5501XS, 5671XS & related tensioners

RENAULT 1.4 16V & 1.6 16V Petrol

Fig. 1

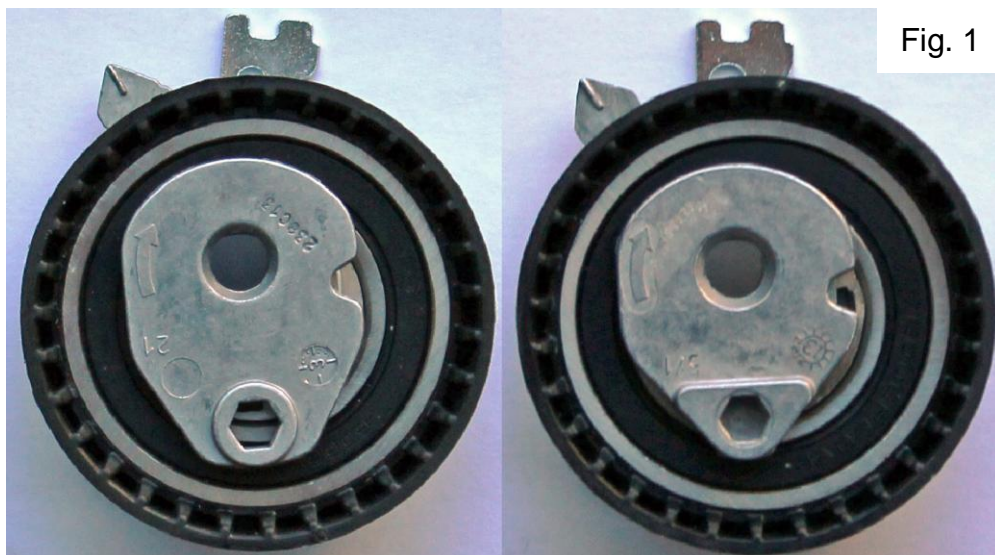
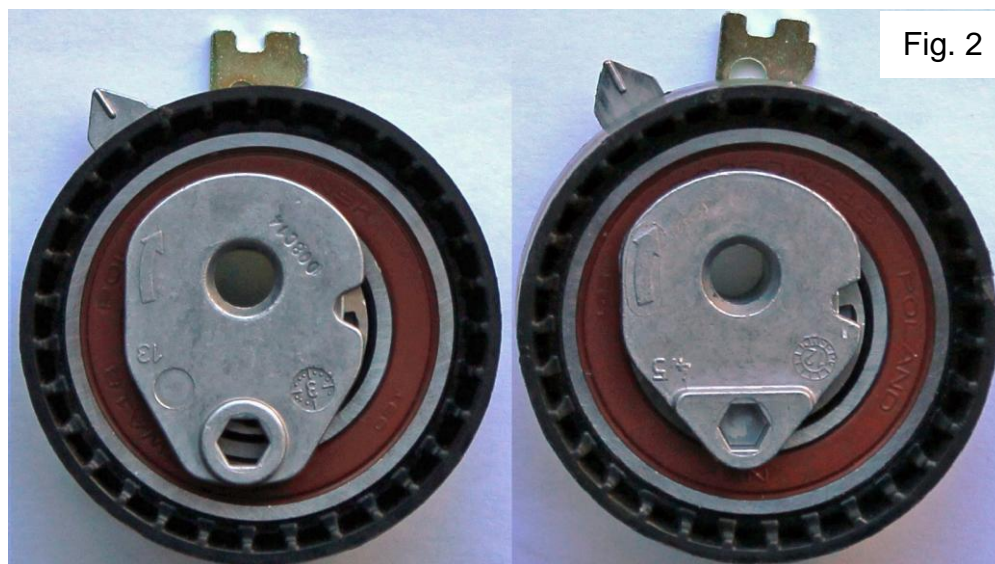
An OEM/OES upgrade has made timing belt 5501XS and the associated tensioners T43064 (Fig. 1 left) or T43168 (Fig. 1 right) as well as the related kits, obsolete. They will no longer be installed on Renault K4M/K4J engines.

Belt 5501XS has been superseded by 5671XS, tensioner T43064 has been superseded by T43236 (Fig. 2 left) and tensioner T43168 has been superseded by T43238 (Fig. 2 right).

All four tensioners appear to be identical, but there is an essential operational difference. New generation tensioners T43236 and T43238 deliver less belt tension and can only be used with the new generation belt: 5671XS, construction designed specifically for this upgrade.

The old belt (5501XS), old tensioners (T43064 and T43168) and kits from your inventory can still be installed on K4J/K4M applications manufactured before 2013. Old generation parts and new generation parts can't be mixed. The new belt (5671XS) may be used on all K4M/K4J applications. However, it must only be used in conjunction with the new generation tensioners (T43236 and T43238).
